Access Compliance Report

Public Rights-of-Way

(Curb Ramps)

Intersection ID: 29801	Main Street: RUDOLPH_DADEY_DR	Cross Street: STEPHENSON_CT	Location: SE
ADA ID: 693B1EDCD77F	Ramp Type: Perp	Initial Pass/Fail: Fail	Overall Compliance: No
Severity Score: 13.75			
Codes/Mitigation Info/Possible Solution		Field Measurements/Component Compliance

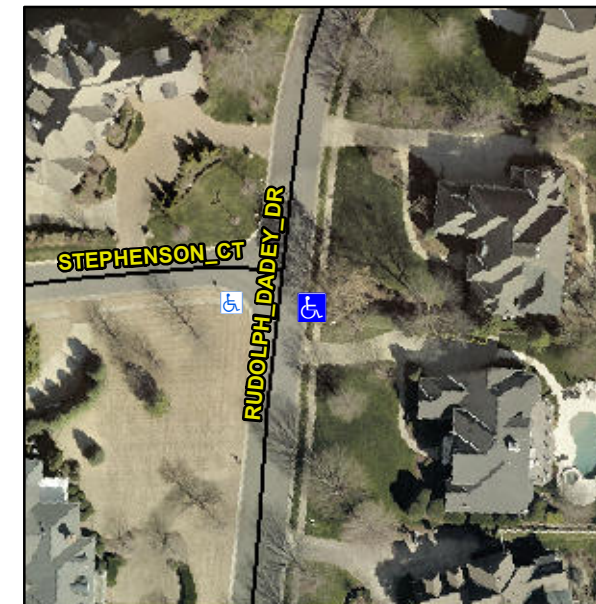
R304.2.2

Compliance	Description	Data	Compliance	Description	Data
N/A	Ramp Length (in)	48.0	No	Ramp Slope (%)	9.9
Yes	Ramp Width (in)	48.0	Yes	Ramp XSlope (%)	2.4
N/A	Flare Type LT	N/A	N/A	Flare Type RT	N/A
N/A	Flare Slope LT (%)	N/A	N/A	Flare Slope RT (%)	N/A
N/A	Flare Traversable LT?	N/A	N/A	Flare Traversable RT?	N/A
N/A	Landing Length (in)	N/A	N/A	DWS Provided?	N/A
N/A	Landing Width (in)	N/A	N/A	DWS Contrast?	N/A
N/A	Landing Slope (%)	N/A	N/A	DWS Length (in)	N/A
N/A	Landing X Slope (%)	N/A	N/A	DWS Full Width?	N/A
N/A	Landing Curb? (Y/N)	N/A	N/A	DWS Offset (in)	N/A
N/A	Shared Landing?	N/A			
N/A	Gutter Ponding?	N/A	N/A	Gutter Slope (%)	N/A
N/A	Gutter Lip Ht (in)	N/A	N/A	Gutter X Slope (%)	N/A
N/A	Painted X Walk1?	No	N/A	Painted X Walk2?	N/A
	X Walk 1 Direction	To NW		X Walk 2 Direction	N/A
N/A	X Walk 1 Width (in)	N/A	N/A	X Walk 2 Width (in)	N/A
	X Walk 1 Slope (%)	1.7		X Walk 2 Slope (%)	N/A
	X Walk 1 X Slope (%)	2.4		X Walk 2 X Slope (%)	N/A

Remove & Replace Entire Ramp.
